Deck Inspection Report

Property Address: 8: osa

The property was inspected on June 13, 2019 at 10:00 am. The purpose for the inspection was to address concerns with the recently built deck. The deck consists of composite decking on wood framing which rests on a storage room. The storage room was built at the same time as the deck. The storage room is considered a room addition as it is on a concrete foundation, attached to the house, is roofed, has exterior load bearing walls, is lit, and has electrical receptacles. It is not considered habitable space as there is no heat or air conditioning. This report will use chapters 3 - 9 of the 2015 International Residential Code, as utilizes and referenced by Bexar County, and the 2017 National Electrical Code as the minimum standards for construction and safety. The following conditions were observed:

2

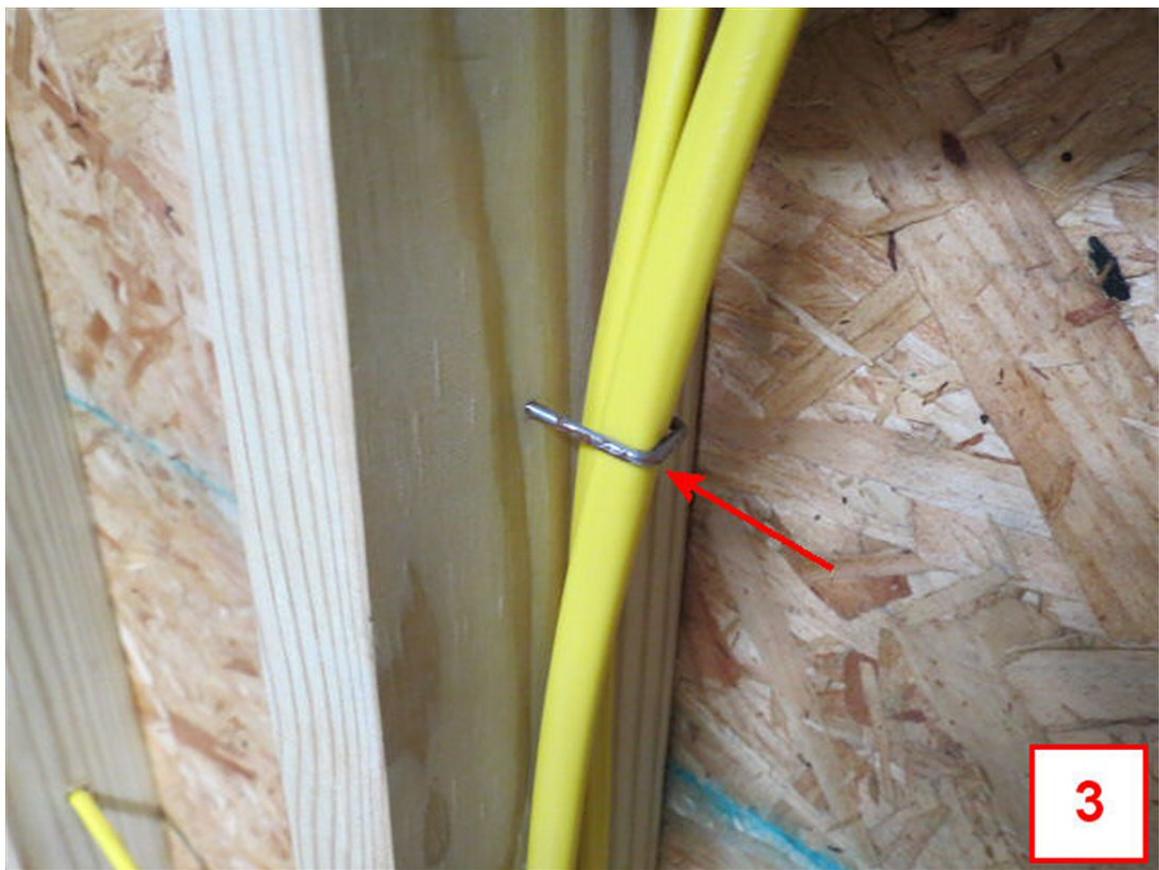
2. Electrical conduit feeding the storeroom is on the ground and needs to be buried 18" deep. If protected by a GFCI breaker, the depth can be reduced to 12" (NEC 300.5). (photo 2)

7

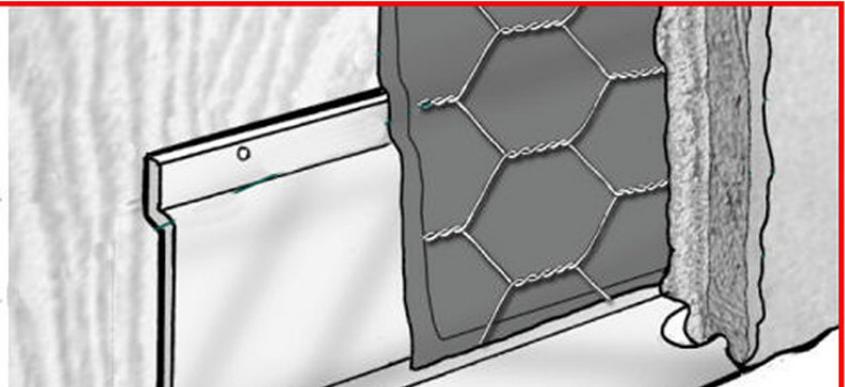
6. Foundation for the storeroom appears to be a patio slab and cannot be used to support a structure. (photo 7)
7. Cedar posts are embedded into the foundation. Wood should never be imbedded in a structural foundation. (photo 8)

#7 Foundation Screed

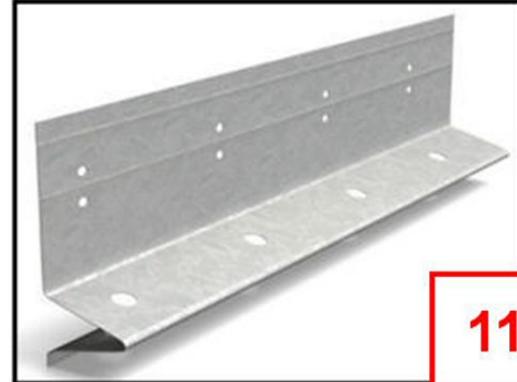
- Required weep screed is not present at the base of the stucco. (photo 9, 10, 11)

A minimum 0.019 inch (0.5 mm) (No. 26 galvanized sheet gage), corrosion resistant weep screed or plastic weep screed, with a minimum vertical attachment flange of 3 1/2 inches (89 mm) shall be provided at or below the foundation plate line on exterior stud walls in accordance with ASTM C 926. The weep screed shall be placed a minimum of 4 inches (102 mm) above the earth or 2 inches (51 mm) above paved areas and shall be of a type that will allow trapped water to drain to the exterior of the building. The weather resistant barrier shall lap the attachment flange. The exterior lath shall cover and terminate on the attachment flange of the weep screed.

12

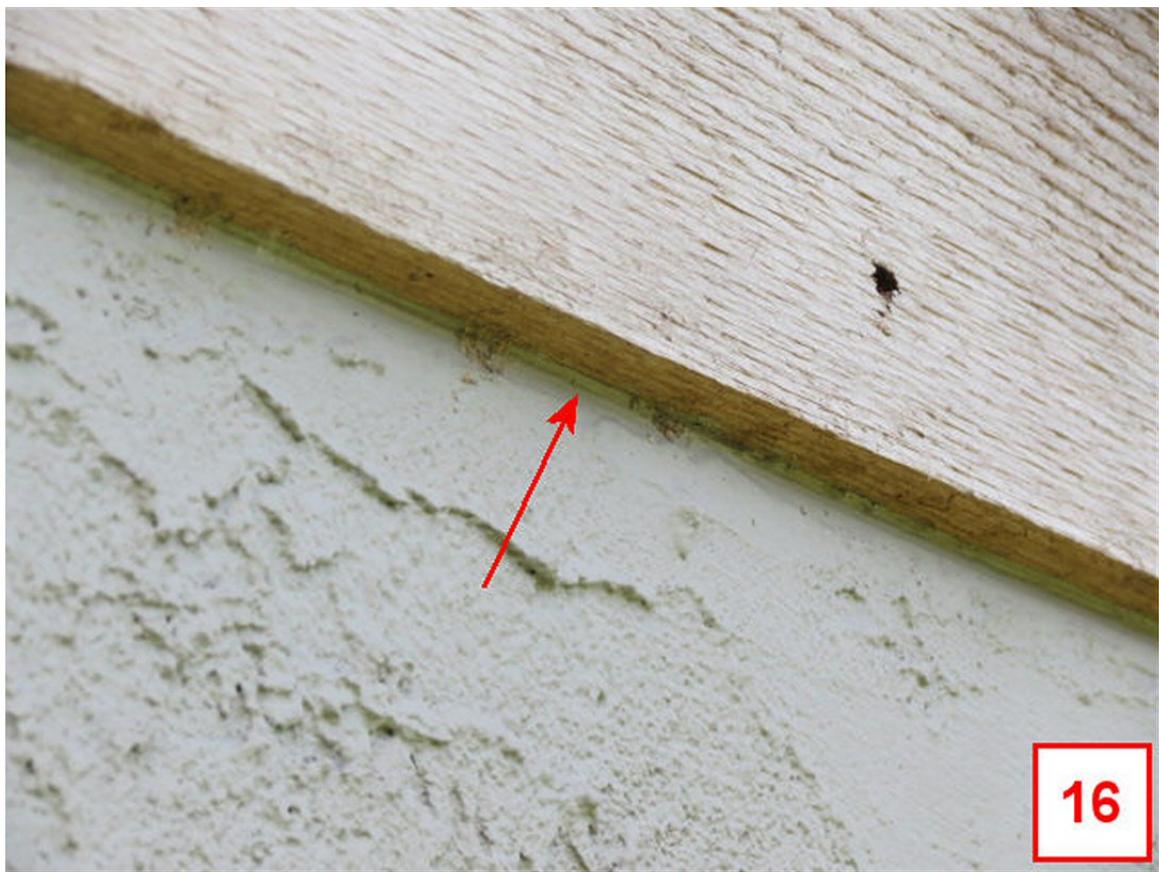
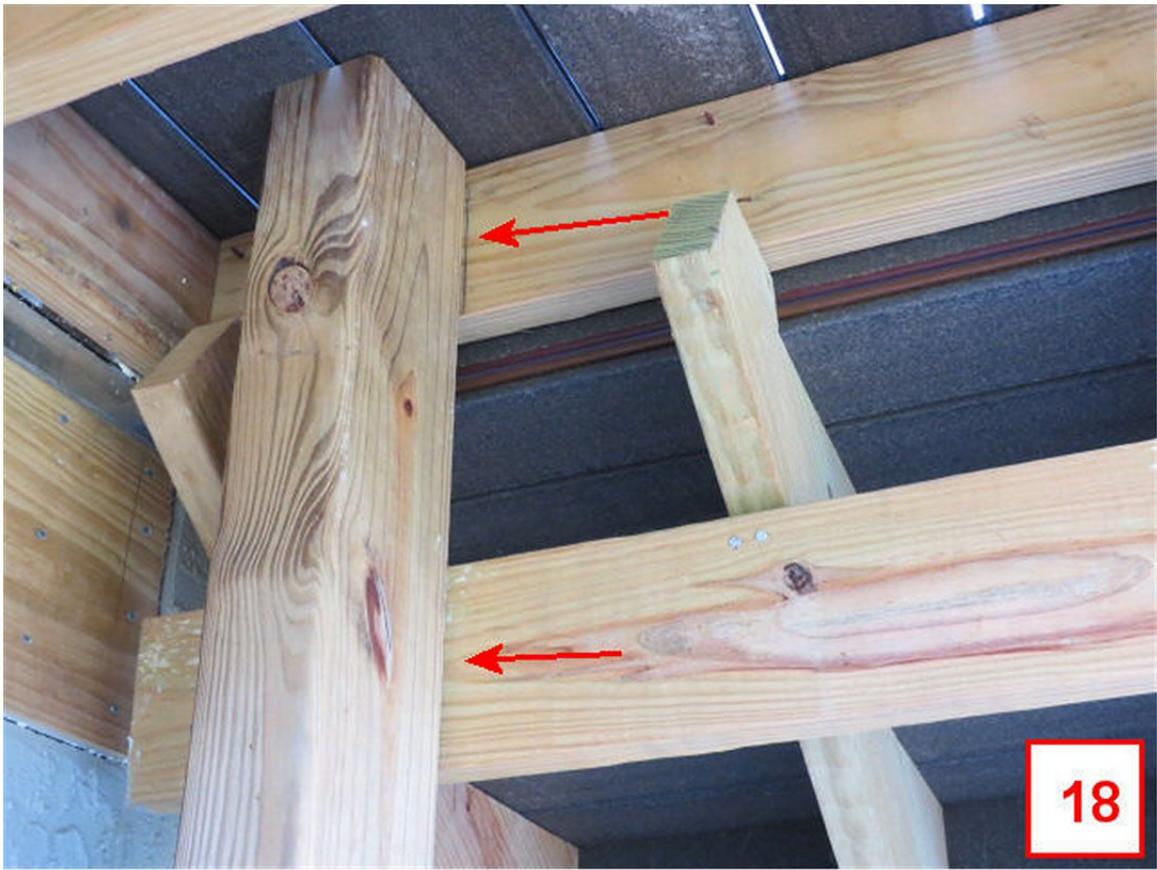
- Roll roofing needs to extend $\frac{1}{2}$ " to $\frac{3}{8}$ " beyond the drip edge flashing. The presence of edge strips could not be verified. (photo 12,13)
- Evidence of water entry is present at the top of the OSB wall sheathing. No head flashing is present at the fascia/trim board above the stucco veneer. (photo 14,15,16)

19

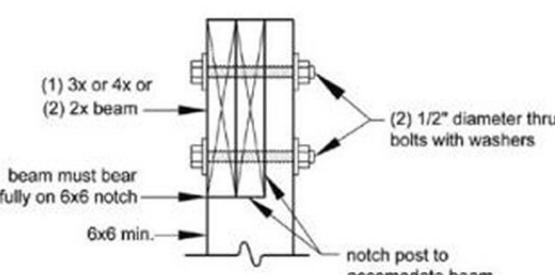
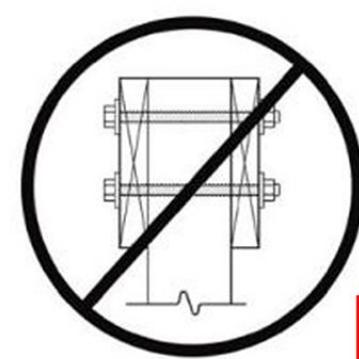
- Evidence of water entry is present at the foundation wall. Proper flashing could not be verified where the roof meets the foundation wall. Caulking or roofing cement should not be relied on to prevent water entry. Refer to IRC 703.4.
- Ledger at the radiusued portion of the house foundation is OSB sheathing. Ledgers in contact must be treated or naturally decay resistant. (photo 17)
- Stair stringers and landing floor framing are not adequately supported. Framing needs to rest on top of the post to provide a continuous load path. (photo 18, 19, 20)

Deck beams shall be attached to supports in a manner capable of transferring vertical loads and resisting horizontal displacement. Deck beam connections to wood posts shall be in accordance with Figures R507.5.1(1) and R507.5.1(2). Manufactured post-to-beam connectors shall be sized for the post and beam sizes. Bolts shall have washers under the head and nut.
